APPEAL SUMMARY

Appeal ID: 31478	Project Address: 4626 SE Clinton St
Hearing Date: 4/12/23	Appellant Name: Isaac Adams
Case No.: B-015	Appellant Phone: 503-226-1575
Appeal Type: Building	Plans Examiner/Inspector: Chanel Horn
Project Type: commercial	Stories: 4 Occupancy: R-2 Construction Type: V-A
Building/Business Name: Peaceful Villa	Fire Sprinklers: Yes - Throughout
Appeal Involves: Erection of a new structure, Reconsideration of appeal	LUR or Permit Application No.: 22-141864-PJ
Plan Submitted Option: pdf [File 1] [File 2]	Proposed use: Multi-family Residential

Code Modification or Alternate Requested To appeal the use of a 2.5:12 roof slope in lieu of 3:12 roof slope in using UL assembly P522, utilizing ceiling assembly #6 and #6D.

Home Forward Peaceful Villa EJ Report 1 Hour Fire Rating of Roof Assembly

Design No. P522

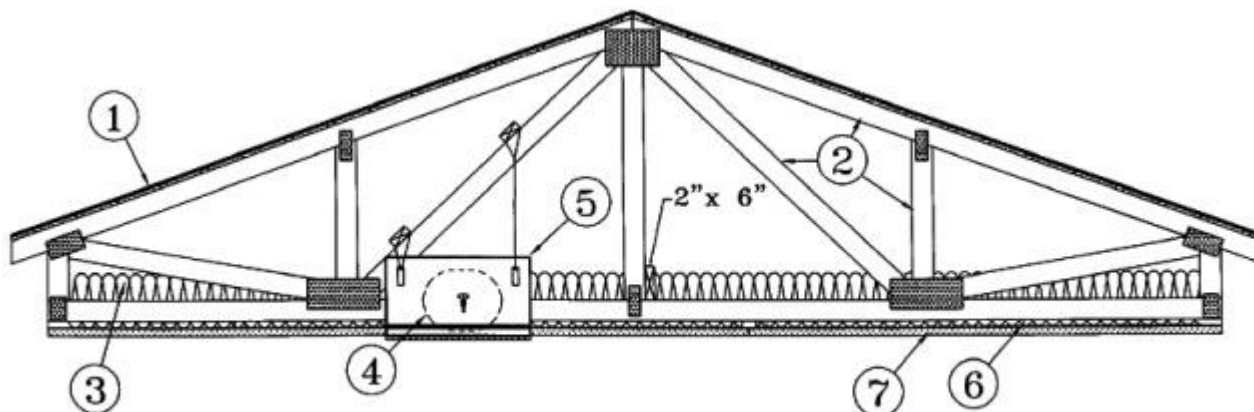
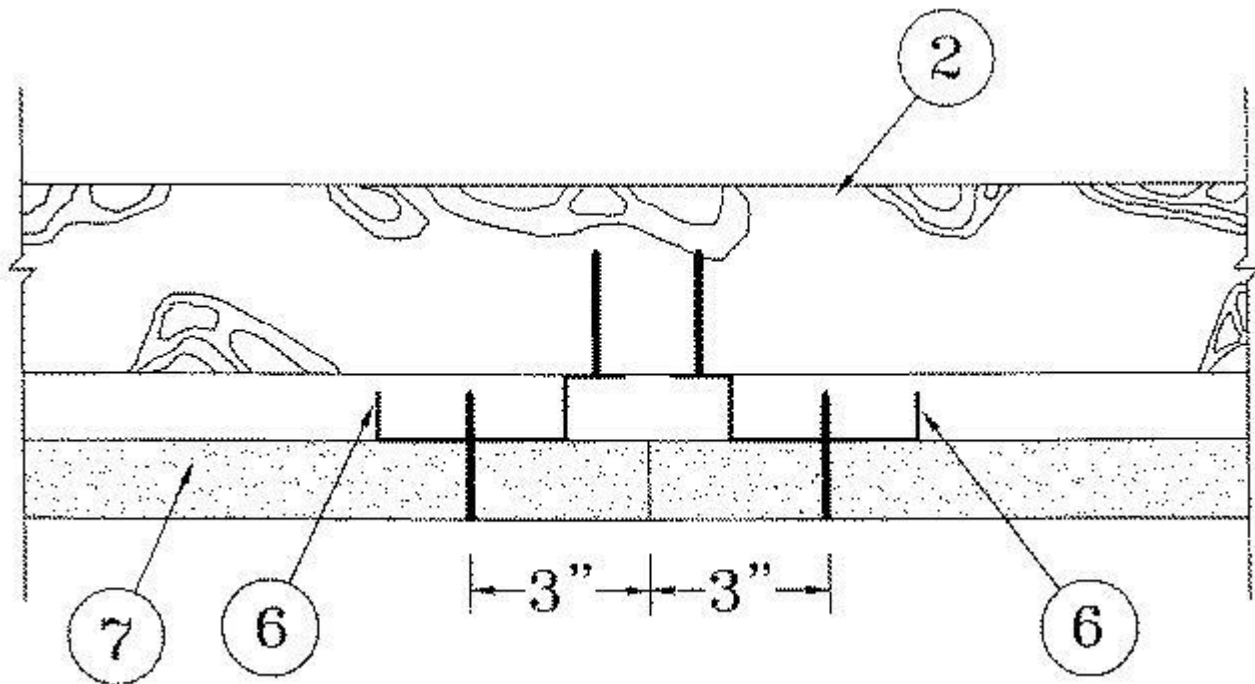
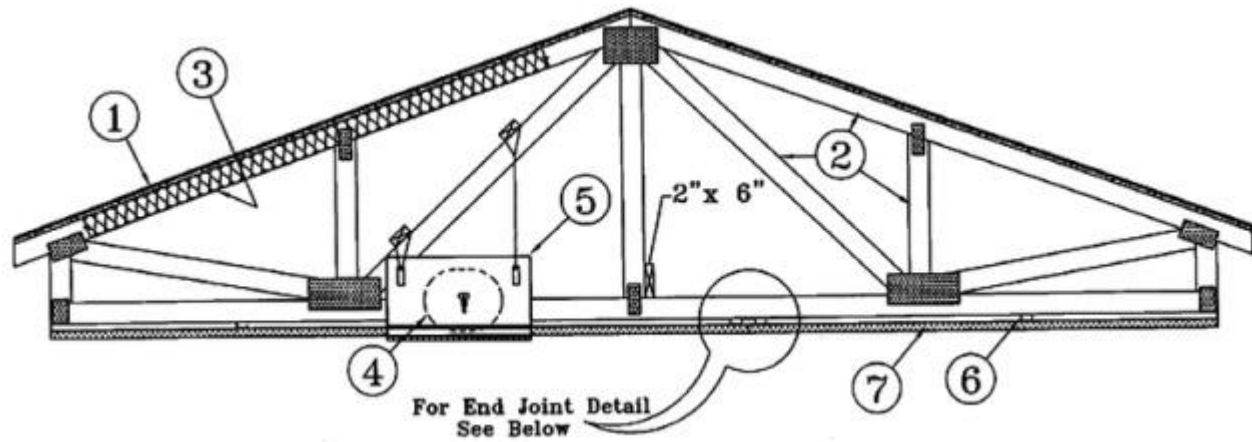
The low slope side of our roof is 2.5/12

Use of UL assembly P522 with reduction in the required roof slope from 3:12 to 2.5:12: Granted as proposed.

Figure 1: Roof Detail

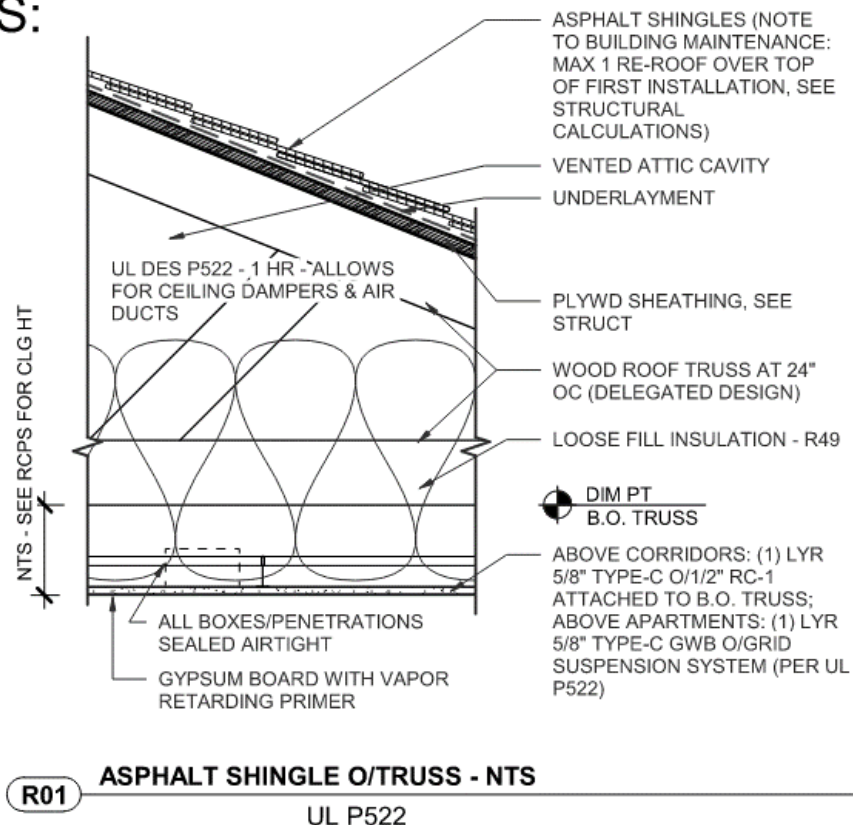
The proposed design is based on UL Design No. P522 for roof assemblies, using ceiling membrane protection items #6 and #6D. The design includes any UL Class A, B, or C roofing system, wood trusses spaced at 24" OC, loose fill insulation, steel framing members, one (1) layer of 5/8" Type C gypsum wallboard, and the ceiling membrane finish system. See **Figure 1** below for proposed detail.

The proposed assembly is compared to UL Design No. P522 as shown in **Figure 2**. The proposed design meets all the requirements of the listed assembly and identical components except for the slope. The proposed design will include a roof slope of 2.5:12 instead of a minimum 3:12 roof slope as detailed in the listed system. This is an important designation as a low slope roof, and requires a membrane for water/ice/snow drainage.

The proposed design meets all the requirements of the listed assembly and identical components except for the slope of 2.5:12 instead of 3:12 roof slope, which shall not decrease the fire resistance rating of the assembly. The proposed assembly will meet or exceed the required 1 hour fire-resistance rating and maintain structural integrity in the case of a fire.

Therefore, the proposed design for the roof assembly will meet or exceed the required 1 hour fire-resistance rating as compared and detailed in this letter when compared to UL Design No. P522 and meet the requirements of the 2022 OSSC when installed as proposed.

Figure 2: UL Design No. P522

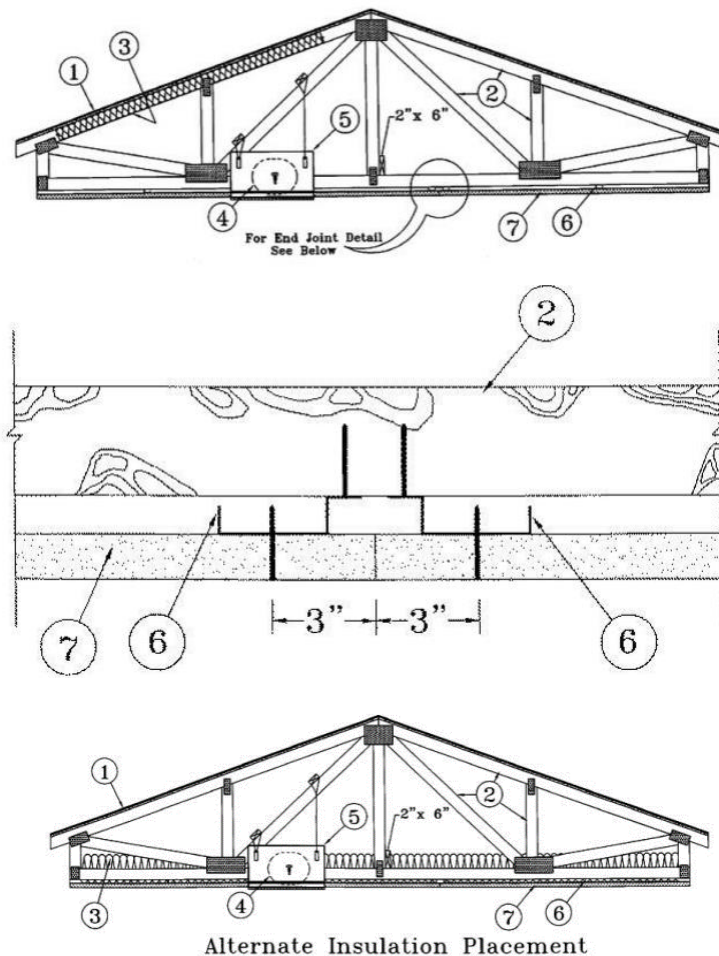
2. Trusses	Pitched or parallel chord wood trusses, spaced a max of 24 in. OC, fabricated from nom 2 by 4 lumber, with lumber oriented vertically or horizontally. Truss members secured together with min. 0.0356 in. thick galv. steel plates. Plates have 5/16 in. long teeth projecting perpendicular to the plane of the plate. The teeth are in pairs facing each other (made by the same punch), forming a split tooth type plate. Each tooth has a chisel point on its outside edge. These points are diagonally opposite each other for each pair. The top half of each tooth has a twist for stiffness. The pairs are repeated on approximately 7/8 in. centers with four rows of teeth per inch of plate width. Where the truss intersects with the interior face of the exterior walls, the min truss depth shall be 5-1/4 in. with a min roof slope of 3/12 and a min. area in the plane of the truss of 21 sq/ft. Where the truss intersects with the interior face of the exterior walls, the min truss depth may be reduced to 3 in. if the batts and blankets (Item 3) are used as shown in the above illustration (Alternate Insulation Placement) and are firmly packed against the intersection of the bottom chords and the plywood sheathing.	Pitched or parallel chord wood trusses, spaced a max of 24 in. OC, fabricated from nom 2 by 4 lumber, with lumber oriented vertically or horizontally. Truss members secured together with min. 0.0356 in. thick galv. steel plates. Plates have 5/16 in. long teeth projecting perpendicular to the plane of the plate. With a roof slope of 2.5/12 (Does Not reduce nor increase FRR)
